UNITED STATES PATENT AND TRADEMARK OFFICE

APPLICATION NO.	FILING DATE	FIRST NAMED INVENTOR	ATTORNEY DOCKET NO.	CONFIRMATION NO.
10/708,879	03/30/2004	Bin Wei	129545-1	2878

Office Action Summary

DETAILED ACTION

FIG. 7(a)

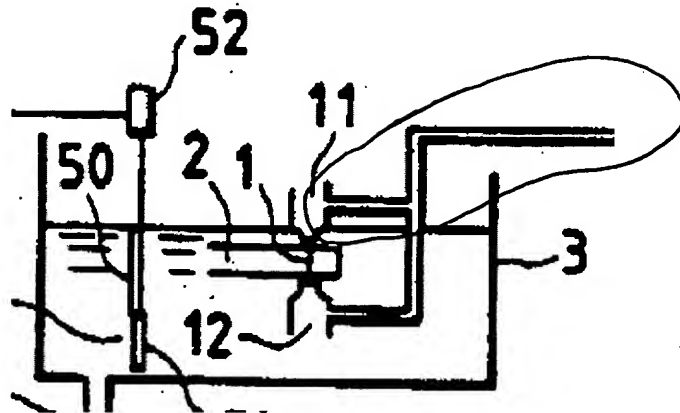
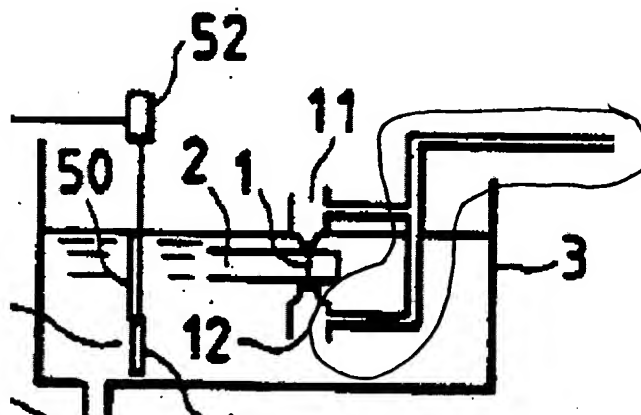
"First Path"

"Second Path"

The Examiner respectfully disagrees with Applicants' assertions. Two paths are disclosed by Suzuki which return fluid to the work tank. Each of the two paths share a common portion. The language of the claims does not preclude the two paths from having a portion in common. The term "***path***" has been given its ordinary meaning. See the definitions cited at Dictionary.com (attached).

The structure disclosed by Suzuki is seen to constitute a "***liquid adding inlet***," since, that is what it does.
